ADDENDUM NO. 1

Raw Water Intake Structure
Edgard Water Treatment Plant
St. John the Baptist Parish, Louisiana

DATE ISSUED: June 7, 2011 EES PROJECT NO. 0933
BID DATE: June 14, 2011

DETAIL 6
CONCRETE SUPPORT PLAN
SCALE: 1/2" = 1'-0"

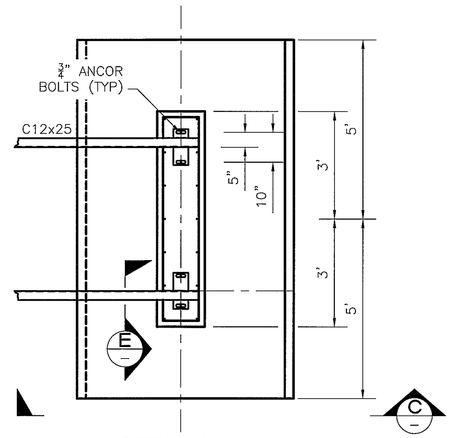
A. Sheet S02

1. **Remove** the note on Detail 6 which reads:

"W 18x26 (typ 2)"

and **Replace** it with the following:

"W 10x26 (typ 2)".
